GOVI MENT OF THE DISTRICT OF COL BIA
OFFICE OF PLANNING

MEMORANDUM

SUBJECT: BZA Application #16965
Application of 2914 11th St. NW, LLC
Square 2853, Lot 813 (including the former Lot 858)

Attachment 1

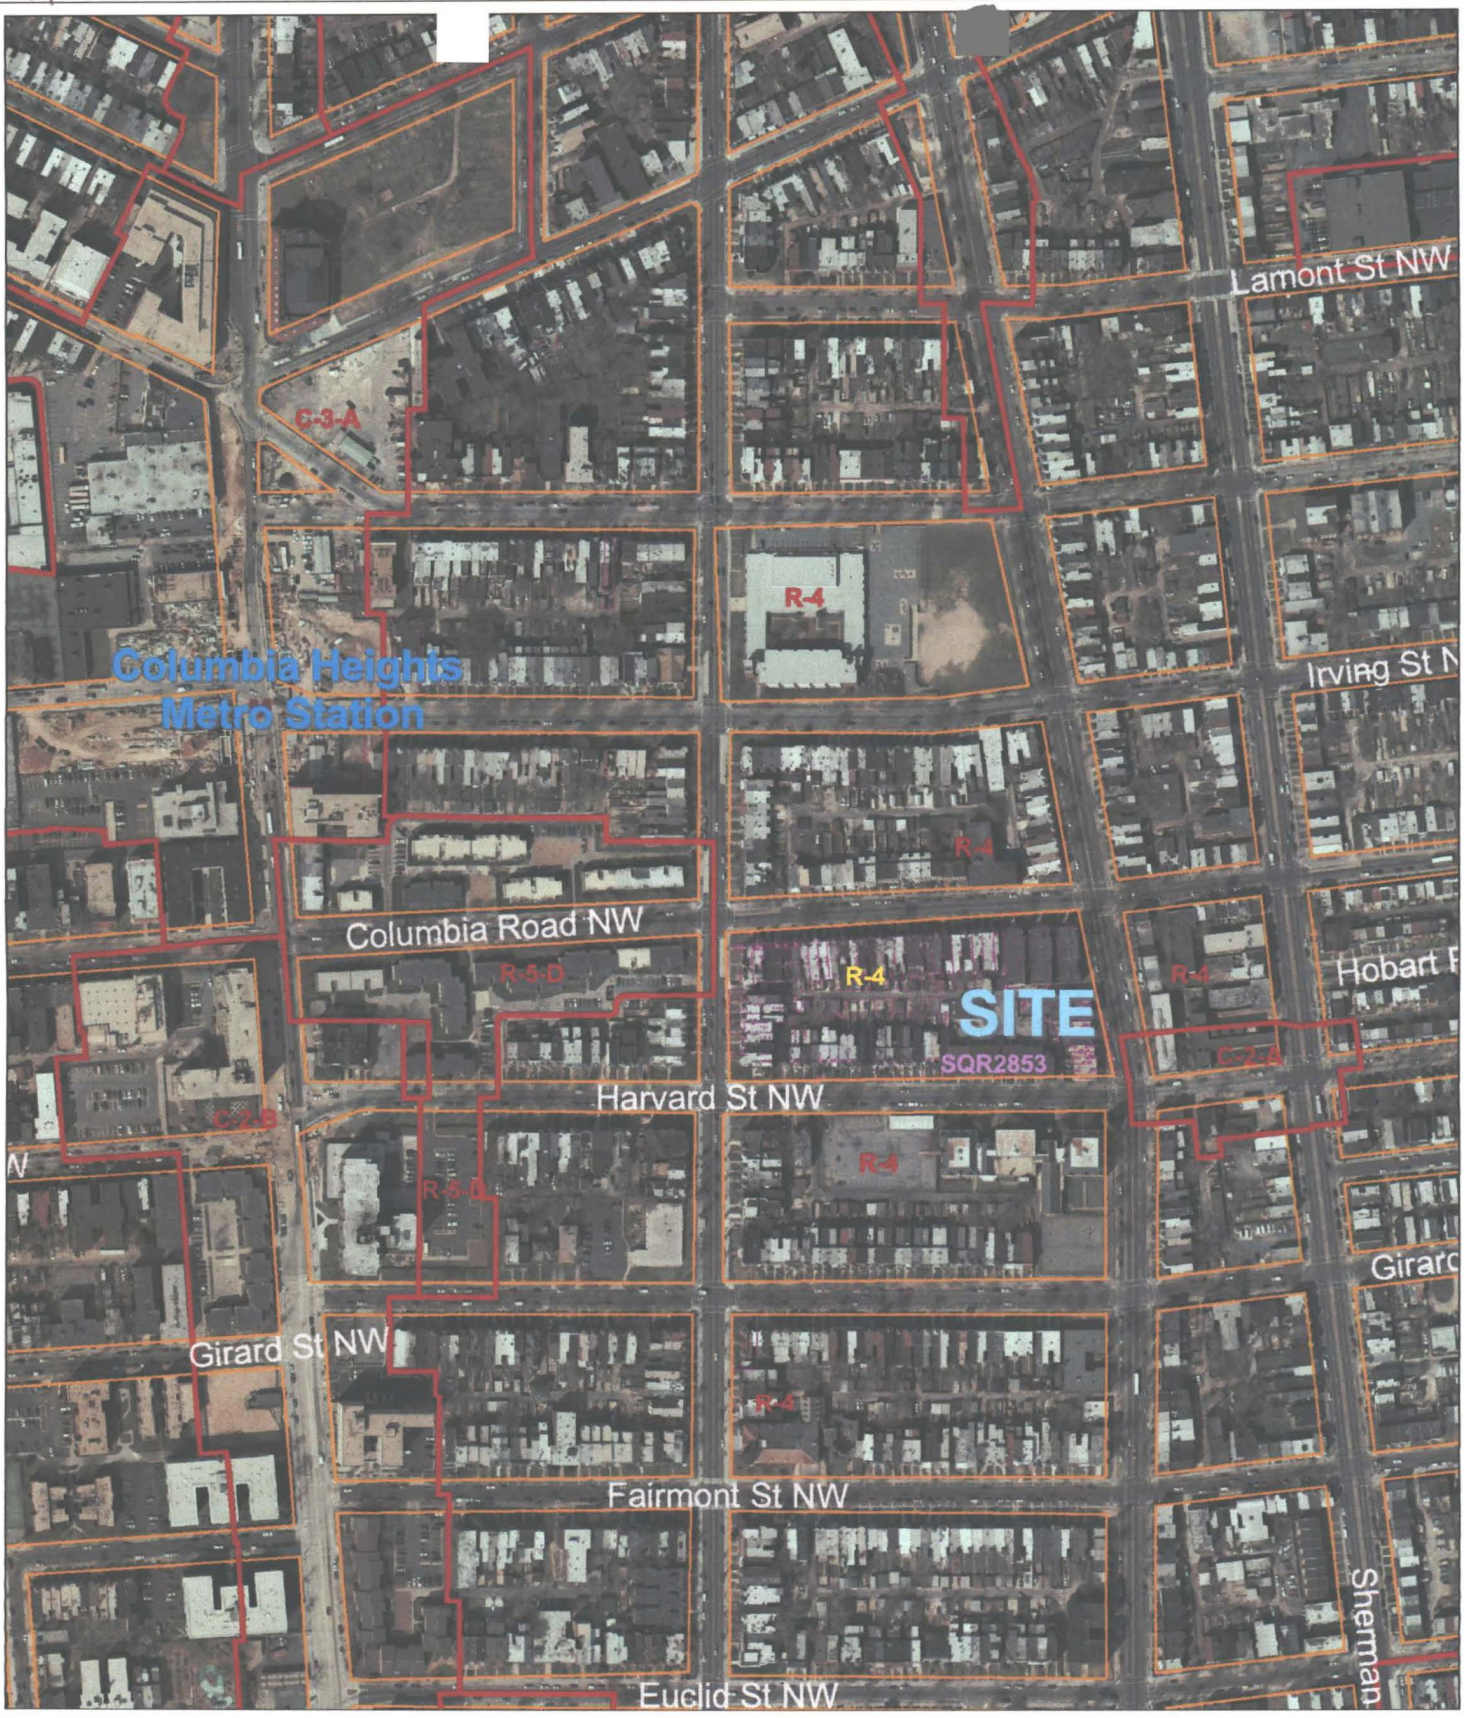
III. SITE AND AREA DESCRIPTION *(See Attachments 1 and 2)*

IV. AREA ZONING AND HISTORIC DISTRICTS *(See Attachment 2)*
